## **CITY OF POUGHKEEPSIE POUGHKEEPSIE, NEW YORK**

### **Replacement of Two (2) Reservoir Tanks at College Hill RFB COP 04-16-01**

# **ADDENDUM NO. 2**

**July 1, 2016**

# HATCH DETAIL

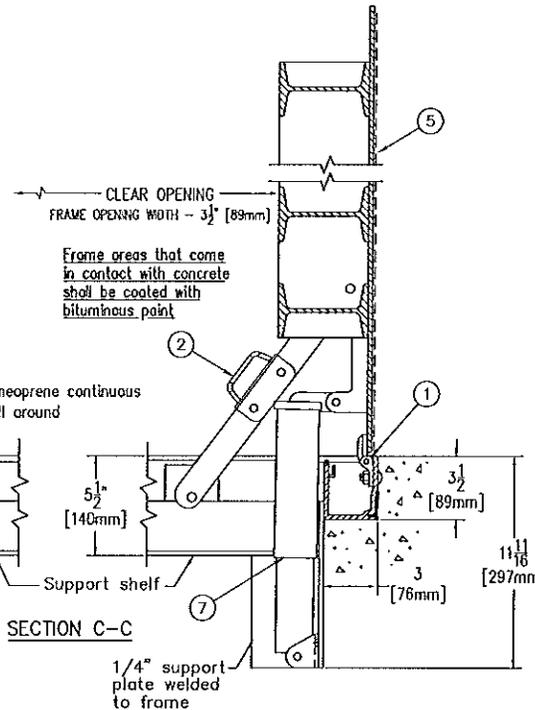
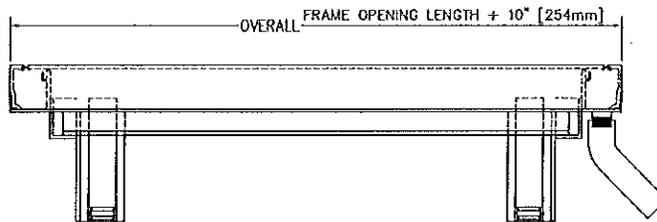
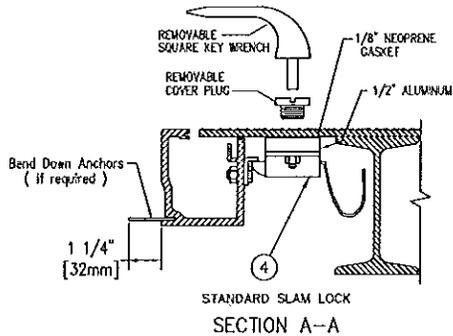
- The hatch door has three different specs depending on where you look. The spec sheet has a JD-4AL (60”x60”) with 300 psf loading, the plan view shows a 42”x60” opening in the roof, and the section view labels it as a JD-2AL H20 load (48”x48”). Do you know which is correct?

**Provide Model J-5ALH20 by Bilco. See attached Detail**
